## Product Change Notice (PCN)

PCN Number: **PCN-0451070R-02**

Product(s) Affected: **PJ-028-SMT-TR**

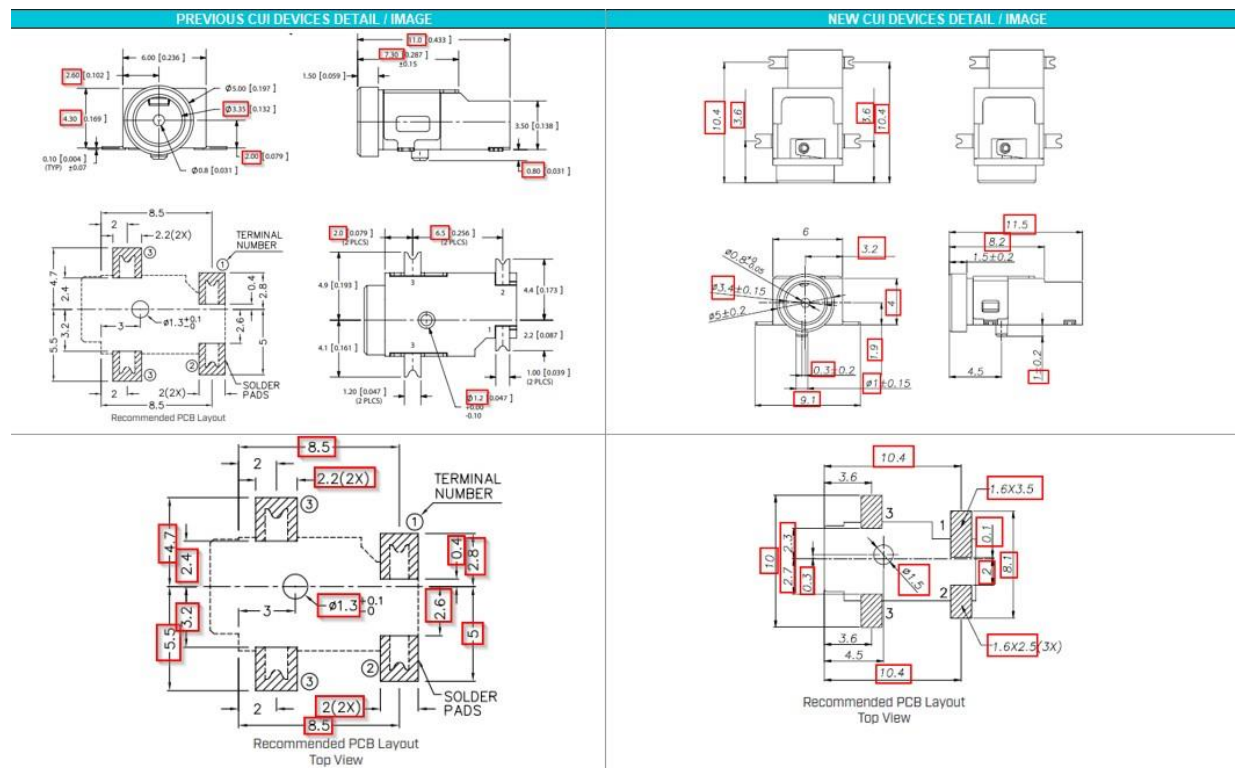
Description of Change: **Minor Housing and footprint differences. Material Change on the housing and terminals. See image Below**

PREVIOUS CUI DEVICES DETAIL / IMAGE	NEW CUI DEVICES DETAIL / IMAGE																																				
 <p>MATING PLUG Jack Insertion Depth: 7.0 mm</p>	 <p>MATING PLUG Jack Insertion Depth: 7.7 mm</p>																																				
<table border="1"> <thead> <tr> <th></th> <th>MATERIAL</th> <th>PLATING</th> </tr> </thead> <tbody> <tr> <td>center pin</td> <td>brass</td> <td>silver</td> </tr> <tr> <td>terminal 1</td> <td>brass</td> <td>silver</td> </tr> <tr> <td>terminal 2</td> <td>copper alloy</td> <td>silver</td> </tr> <tr> <td>terminal 3</td> <td>copper alloy</td> <td>silver</td> </tr> <tr> <td>plastic</td> <td>PA10T</td> <td></td> </tr> </tbody> </table>		MATERIAL	PLATING	center pin	brass	silver	terminal 1	brass	silver	terminal 2	copper alloy	silver	terminal 3	copper alloy	silver	plastic	PA10T		<table border="1"> <thead> <tr> <th>DESCRIPTION</th> <th>MATERIAL</th> <th>PLATING/COLOR</th> </tr> </thead> <tbody> <tr> <td>center pin</td> <td>brass</td> <td>gold</td> </tr> <tr> <td>terminal 1</td> <td>brass t=0.20</td> <td>gold</td> </tr> <tr> <td>terminal 2</td> <td>phosphor bronze t=0.25</td> <td>gold</td> </tr> <tr> <td>terminal 3</td> <td>phosphor bronze t=0.20</td> <td>gold</td> </tr> <tr> <td>housing</td> <td>PA9T (UL94V-0)</td> <td>black</td> </tr> </tbody> </table>	DESCRIPTION	MATERIAL	PLATING/COLOR	center pin	brass	gold	terminal 1	brass t=0.20	gold	terminal 2	phosphor bronze t=0.25	gold	terminal 3	phosphor bronze t=0.20	gold	housing	PA9T (UL94V-0)	black

MATERIAL	PLATING																																			
center pin	brass	silver																																			
terminal 1	brass	silver																																			
terminal 2	copper alloy	silver																																			
terminal 3	copper alloy	silver																																			
plastic	PA10T																																				
DESCRIPTION	MATERIAL	PLATING/COLOR																																			
center pin	brass	gold																																			
terminal 1	brass t=0.20	gold																																			
terminal 2	phosphor bronze t=0.25	gold																																			
terminal 3	phosphor bronze t=0.20	gold																																			
housing	PA9T (UL94V-0)	black
